# TECHNICAL BULLETIN 013

21/04/2006

## RENAULT 1.5 DCI / ACCESSORY DRIVE / INSTALLATION INFO

FIG. 1

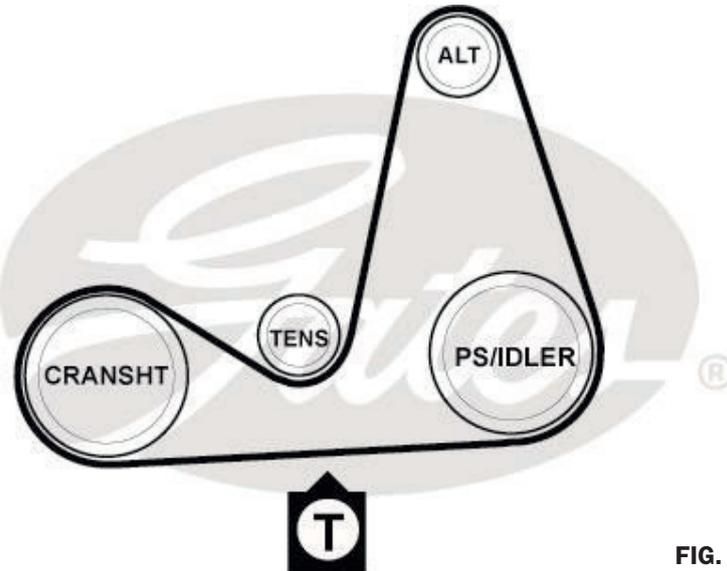
Certain Renault 1.5 dCi models, produced between June 2001 and June 2002, **without air-conditioning**, could have issues with the accessory drive belt, as a result of tensioner problems.

The tensioner base plate could deform, resulting in misalignment, belt noise and early failure.

In order to cure this, Renault launched a technical note, saying the old tensioner (OE ref. 8200262773, 8200292784) together with the 2 tensioner bolts (torx-head) as well as the accessory drive belt (OE ref. 8200020924) have to be replaced.

8. Tension the belt: the belt has to be tensioned (with tool Mot.1638, OE ref. 0000163800) to a higher tension than with the original drive set-up. Measure the tension in the bottom span, between the crankshaft and power steering pump (or idler for cars without power steering) (Fig.1).
9. When measuring the belt tension with the STT-1, key in "8", "180" (virtual span of 180 mm). When measuring with the Krikit®, tension has to be 70 Kg.
10. Now tighten both bolts (36 Nm).
11. Rotate the engine 2 revolutions clockwise.
12. Check the tension and adjust if needed.
13. Re-install all removed parts.
